**RFP: CC-21  
AIRPORT HANGAR AT LOWCOUNTRY REGIONAL AIRPORT  
RFP DUE: Tuesday, December 1, 2015 @ 11:00am**

**Addendum #4**  
**(This is the final addendum for this project)**  
This addendum is dated November 24, 2015

Sheet No.  
**F-1**

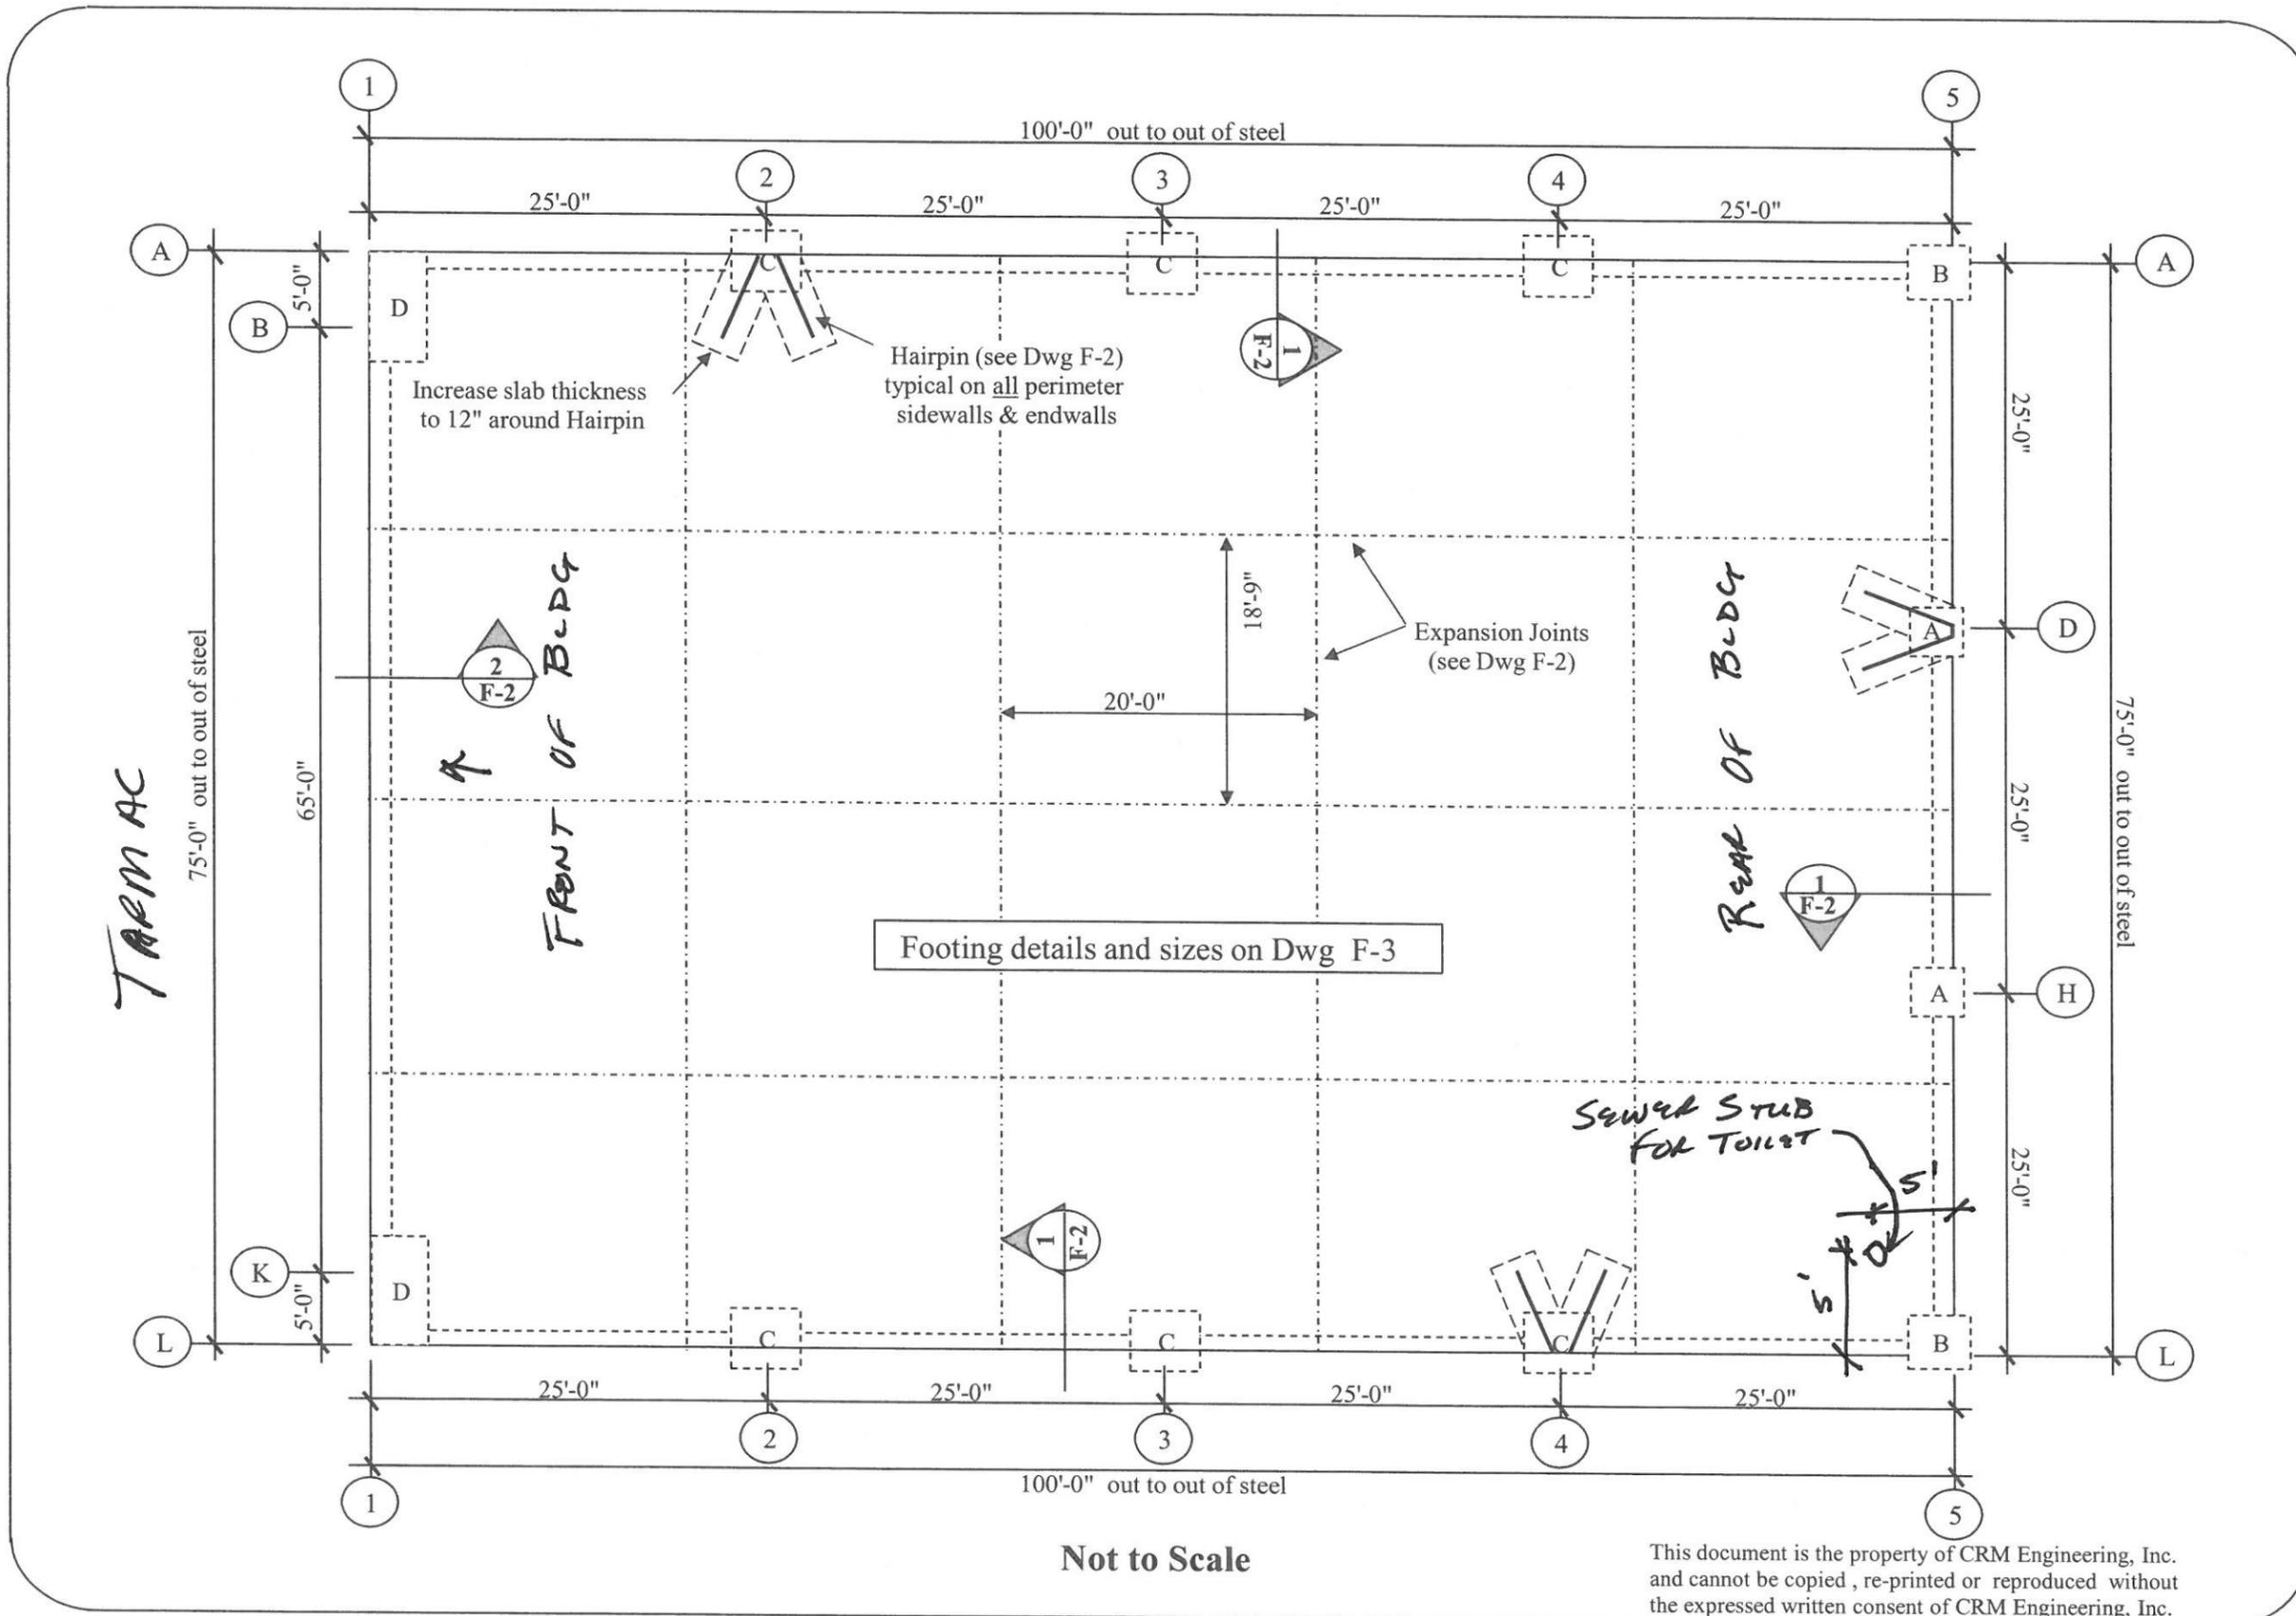
Question 5 – What is the septic line location within the building? **Answer:** See drawing attached to this addendum for the location of the septic line within the building.
